Technical Service Bulletin: TSB210023

Choosing Correct Exhaust Gas Recirculation (EGR) Temperature Sensor with Replacement of Main Engine Wiring Harness

- X15 CM2350 X114B - Efficiency Series
- X15 CM2350 X116B - Performance Series

Figure 1, New Engine Wiring Harness, Part Number 5484117 and New EGR Temperature Sensor, Part Number 5461596.

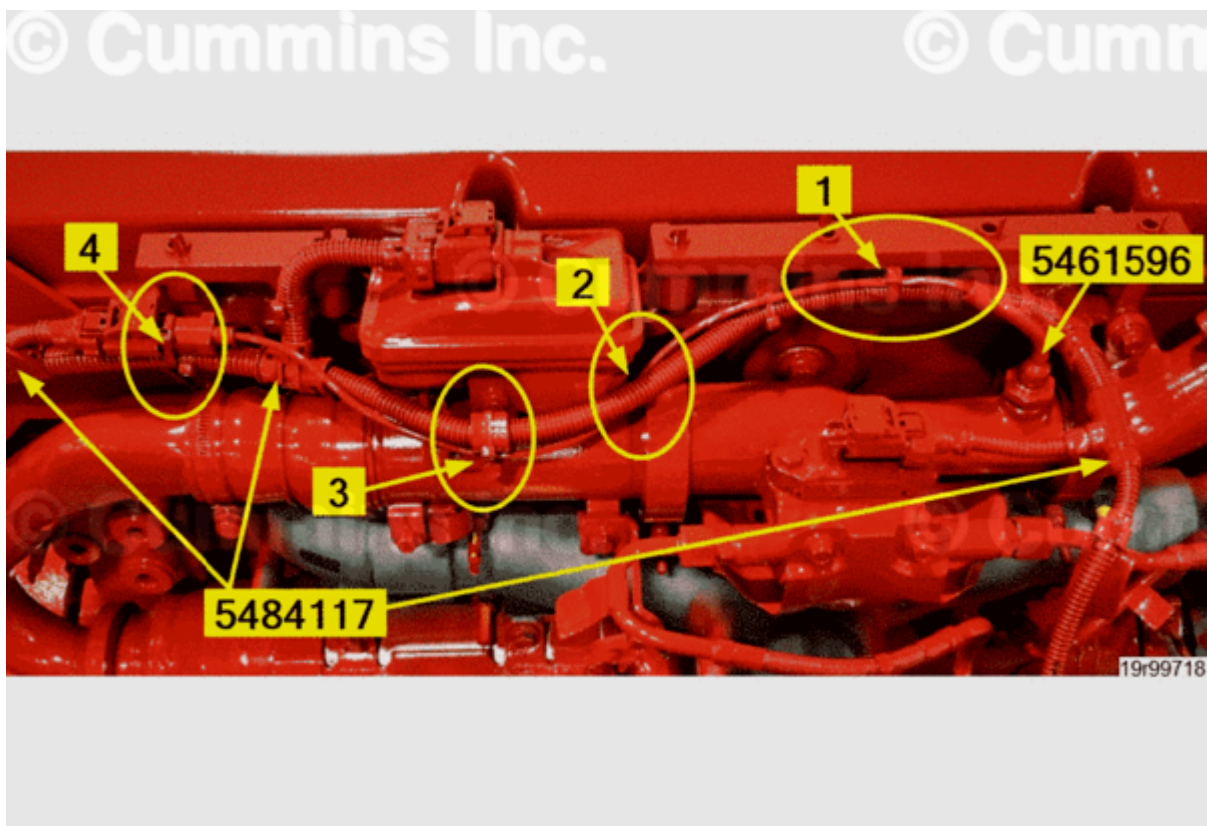
- The exhaust gas recirculation (EGR) temperature sensor and engine wiring harness designs of the products affected have changed.
- Because of differences between the existing EGR temperature sensor design and the new EGR temperature sensor design used on the products affected, there will be an incompatibility encountered when attempting to reconnect the existing EGR temperature sensor, Part Number 2872140, to the replacement engine wiring harness, Part Number 5484117.
- A new EGR temperature sensor, Part Number 5461596, will need to be ordered if installing replacement engine wiring harness, Part Number 5484117, and the engine is equipped with the existing EGR temperature sensor, Part Number 2872140.

If the existing EGR temperature sensor requires replacement due to engine wiring harness compatibility, see Figure 1 below and Routing Instructions, to securely route and tie down new EGR temperature sensor lead cable.

1. Route cable on top of engine wiring harness and use one wire tie, Part Number 3062329, or equivalent.
2. Route cable behind engine wiring harness as shown.
3. Position cable underneath P-clip as shown, connect to engine wiring harness connector and secure secondary (red) latch.
4. Tie down EGR temperature sensor interconnect to harness exactly at location shown using one wire tie, Part Number 3062329, or equivalent.

Figure 3, New Production EGR Temperature Sensor, Part Number 5461596.

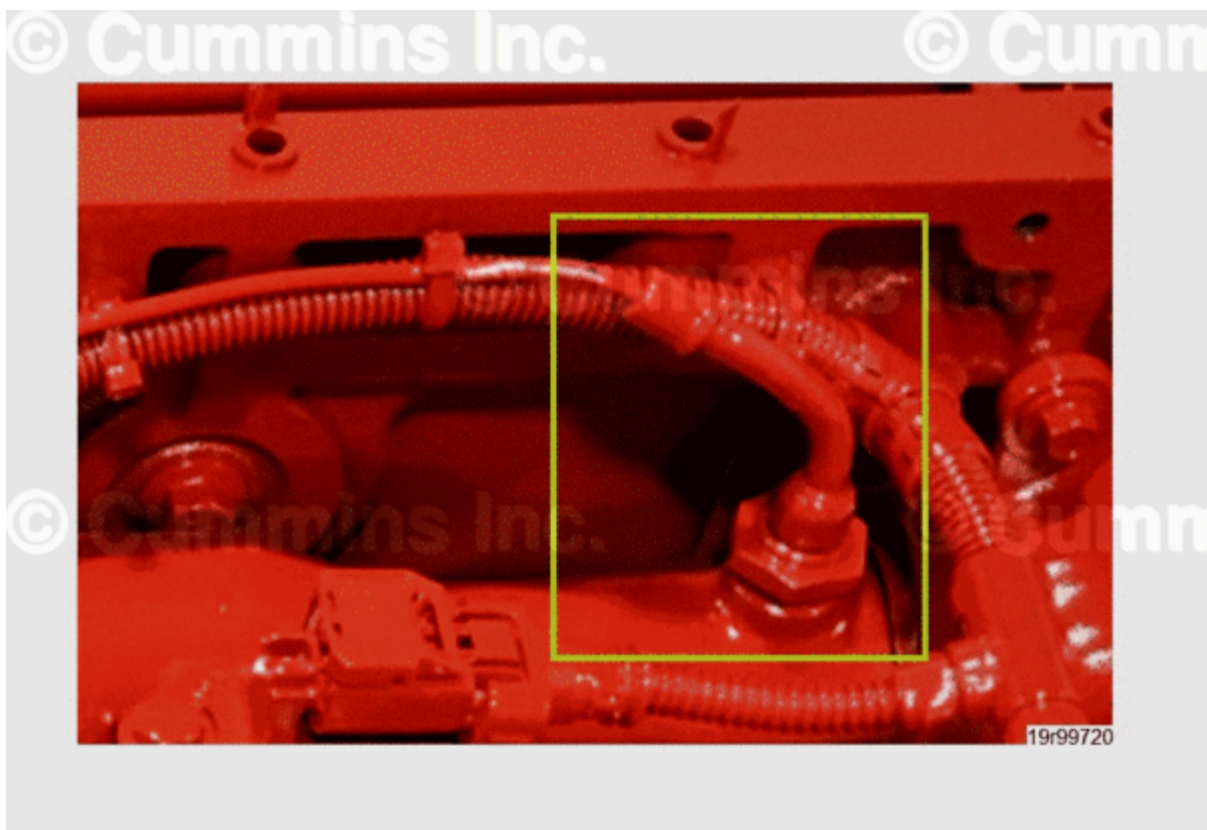
- Figure 3 above shows the new production version of the EGR temperature sensor, Part Number 5461596. The sensor connector **must** be held in place with one wire tie as shown above in Figure 1.
- This new sensor uses a single jacketed, silicone rubber-insulated cable with a long grey, flexible silicone rubber strain relief/seal component.
- Existing and new EGR temperature sensors will have their respective part numbers stamped upon the stainless-steel casing below the hex flats.
